Quality Control Check Report. Stage: After Finishing Stage III (Apartments)

Flat No	A-801	Other	Sl. No.	38355
Company	MPL	Project	Phase	
Prepared by	T. Vinod Kumar	Sign	Date	14-09-21
Project Manager	Subba Reddy	Sign	Date	14-09-21
Previous stage report no.	37517	Report filed and signed by PM	☒ Yes ☐ No	
Checked By MD on		MD Sign	For filling	☐ Yes ☐ No

MAYFLOWER PLATINUM

Details of Additions & Alterations

PLUMBING PLAN OF A1

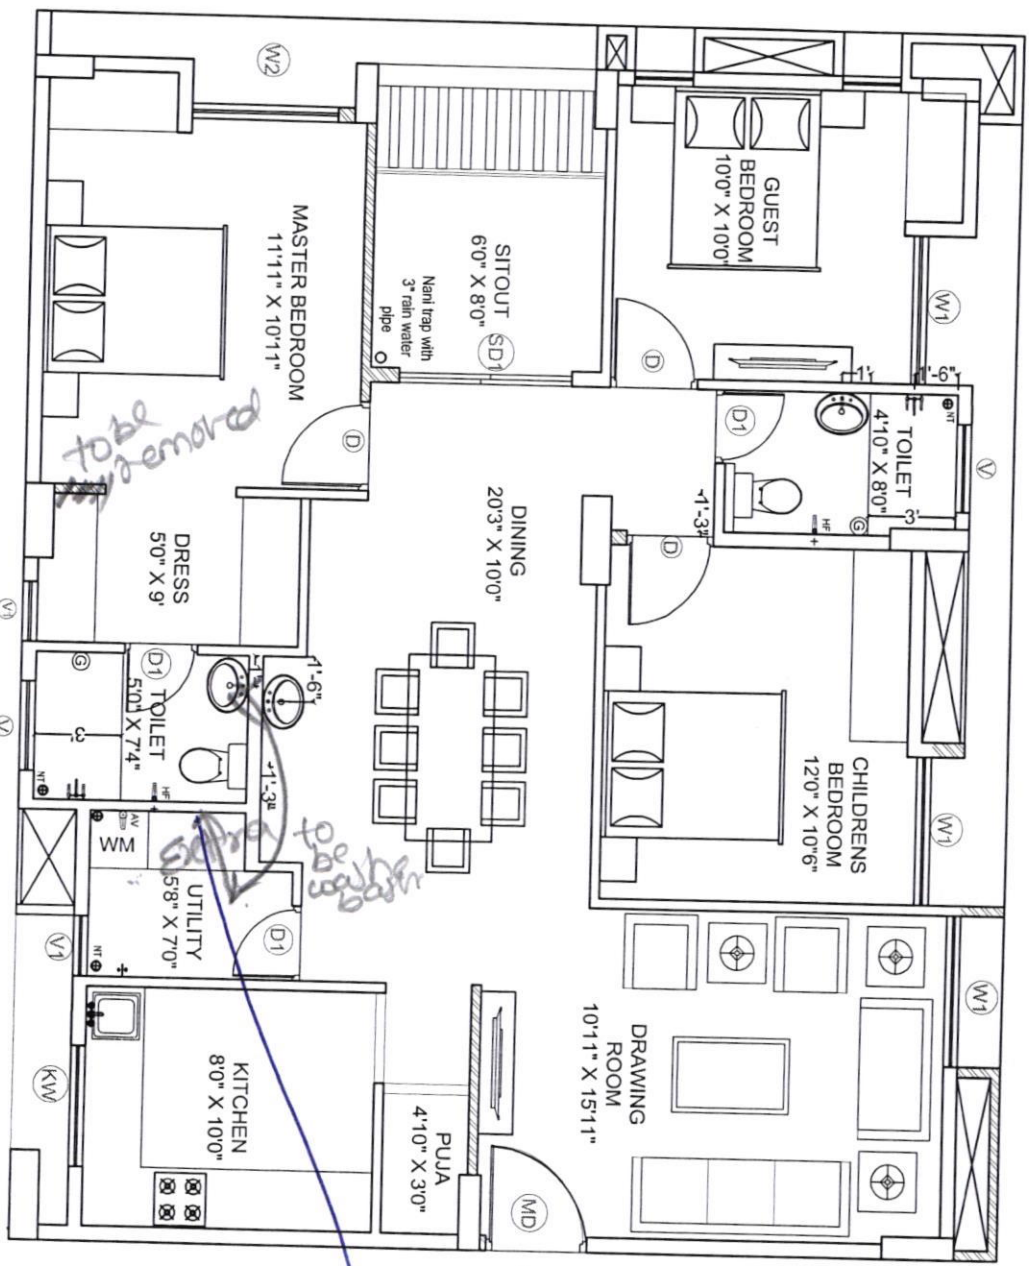
Choice of Bathroom tiles, CP fittings & Sanitary ware:

① customer will buy tiles of bathroom except utility.

ELECTRICAL PLAN OF FLAT-A1

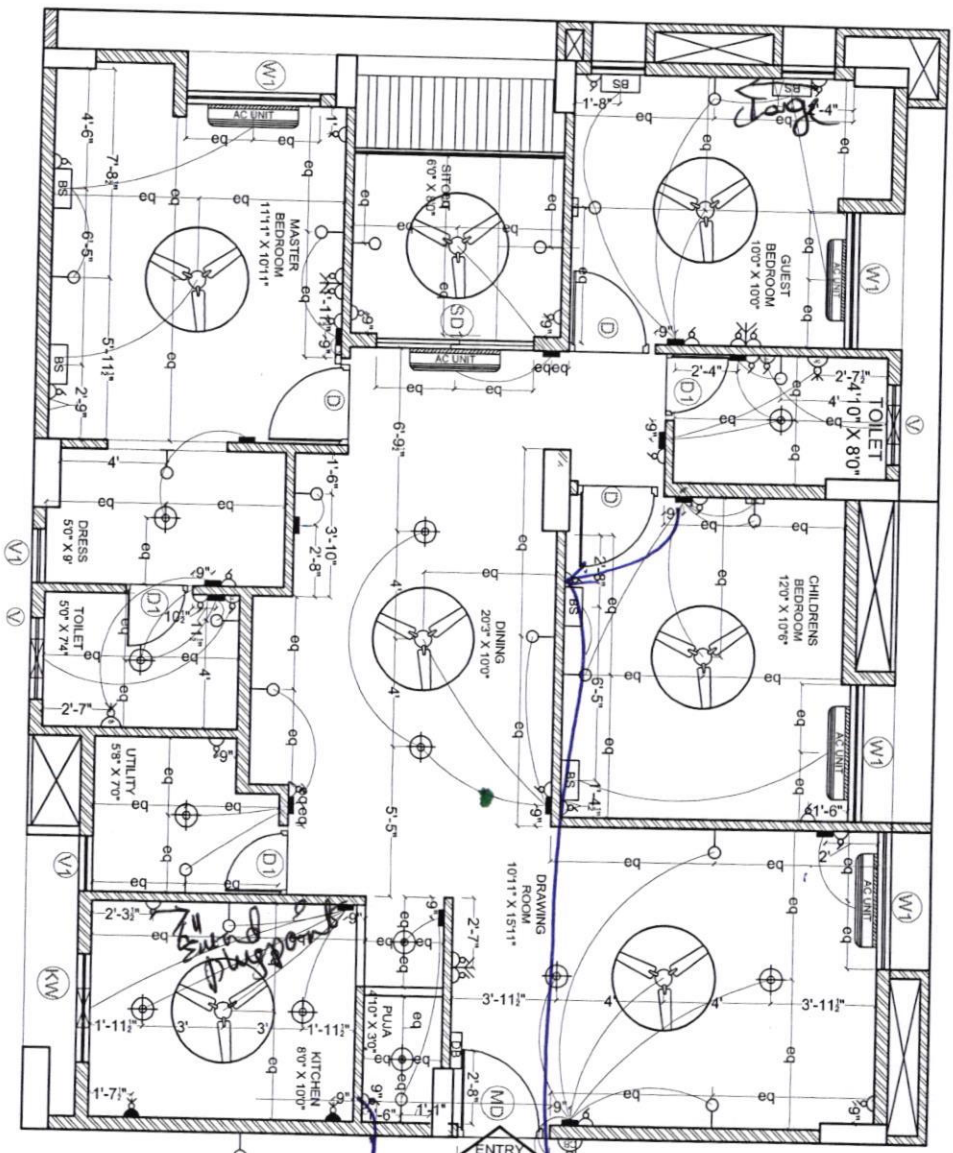
Changes in electrical points: (mark on plan)

① marked on plan

Switches to be listed
4 1/2, 4 1/2, 1/2, 1/2
